**From:** [Les Stevens](#)  
**To:** [A303 Sparkford To Ilchester](#)  
**Cc:** [REDACTED] [Les Stevens](#)  
**Subject:** Deadline 4 Submission on behalf of Mr B G Norman  
**Date:** 07 March 2019 16:56:47  
**Attachments:** [Deadline 4 Submission on behalf of Mr B G Norman.pdf](#)

Ref: SPIL-AFP001  
Bryan G. Norman  
6<sup>th</sup> March 2019  
Deadline 4

# A303 Sparkford to Ilchester Improvement

LPR 1

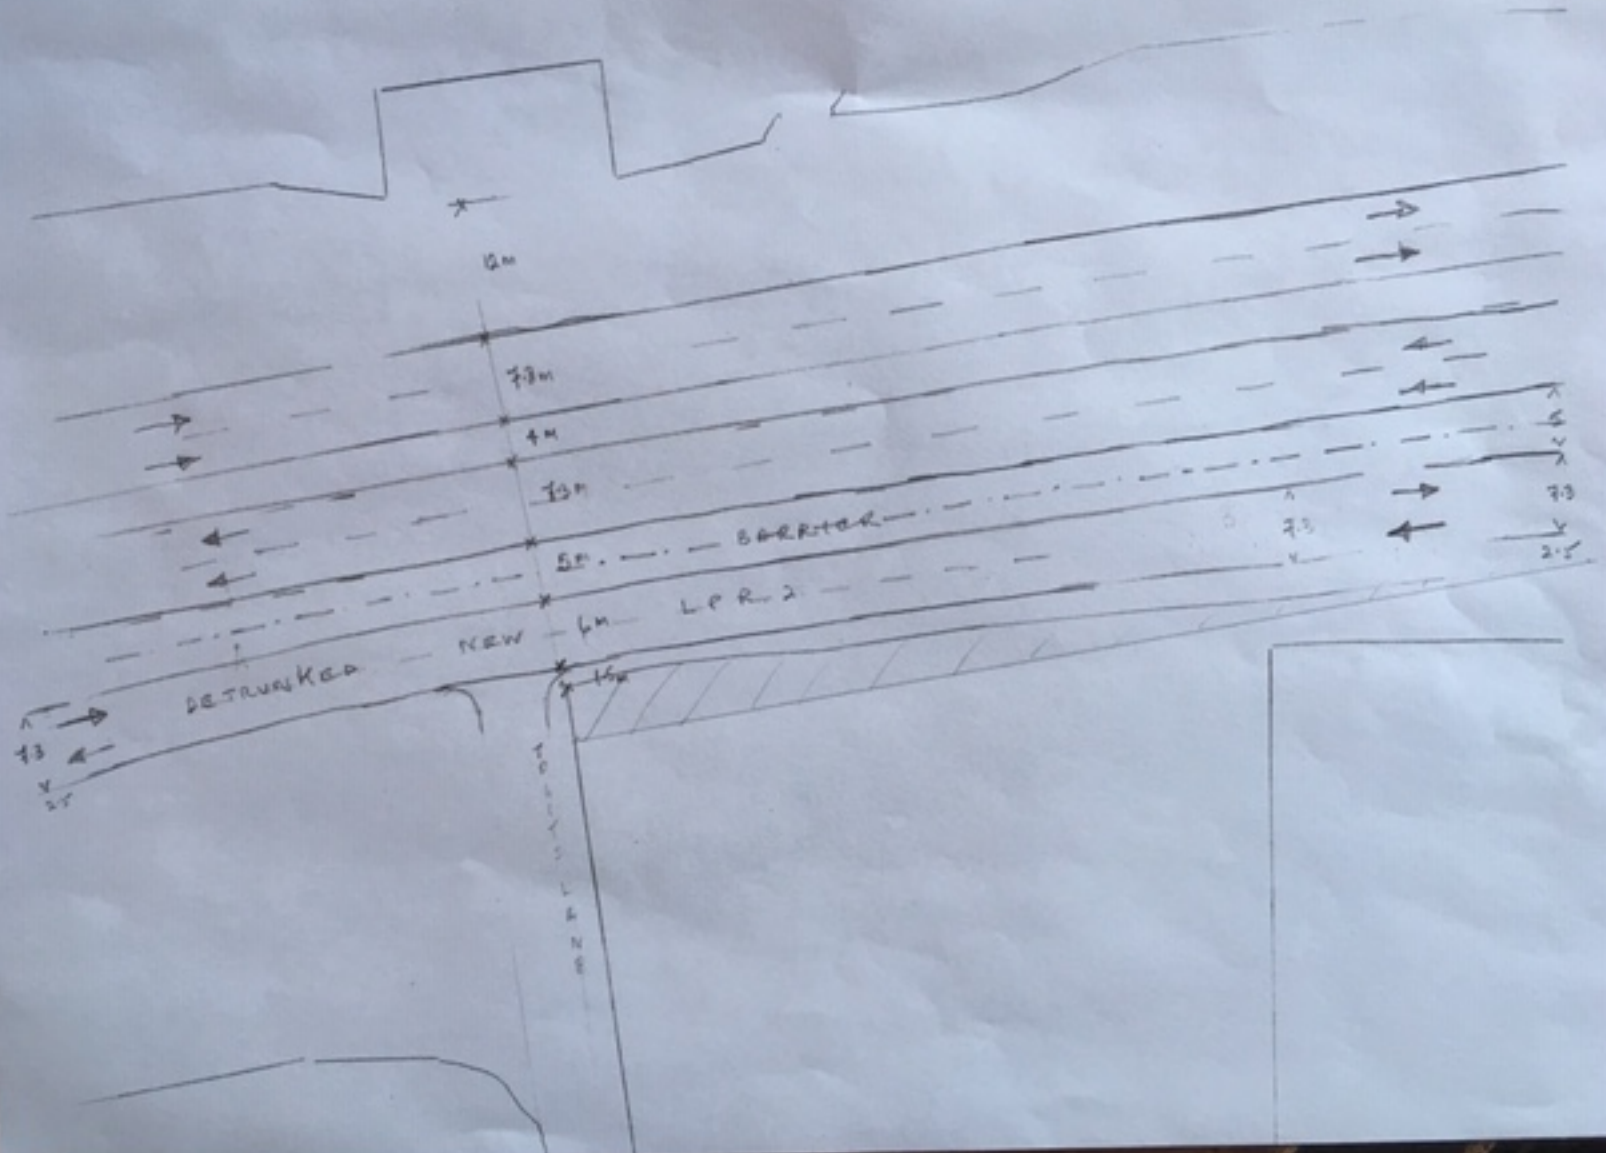
LPR 1 – shows the full specification: 7.3 m. and 2.5 m. road can be built whilst delaying approximately 86 m. of the West carriageway. This will entail temporary concrete barriers being erected roughly on the existing North curb line to separate the road from construction work together with changed markings. This would last until the East carriageway came into use.

LPR 2

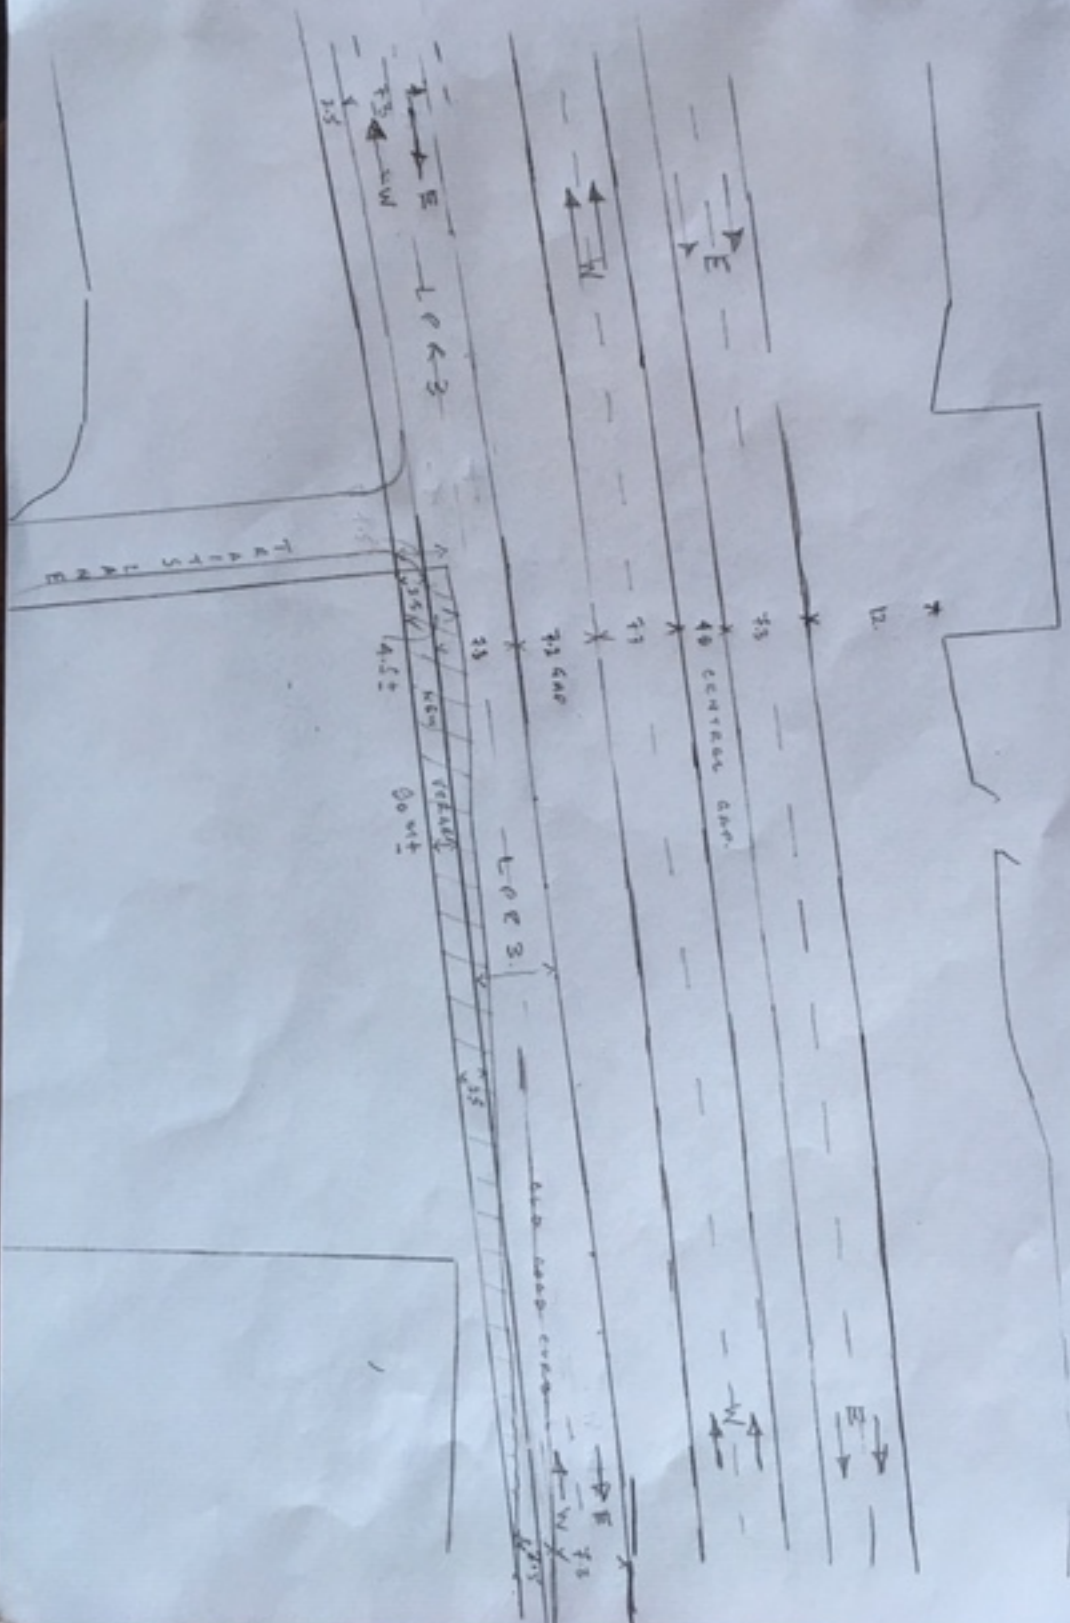
LPR 2 – For convenience a copy of Fairhurst Drawing 127142/1001 this shows how, when detrunked the LPR reduced to 6 m. and 1.5 m., can still be built through the pinch point without the use of any M.O.D. land. This will involve further work at the end of the contract period to reduce the dimensions from those in LPR 1 above and enable the last 86 m. of the West carriageway to be built when temporarily the new East carriageway can be used for two way traffic to avoid road closures.

LPR 3 – This shows the clear advantage of acquiring approximately the 4.5 m. by 90.0 m. sliver of non-operational land from the M.O.D. It will also avoid the necessity of reducing the width of the LPR when detrunked.
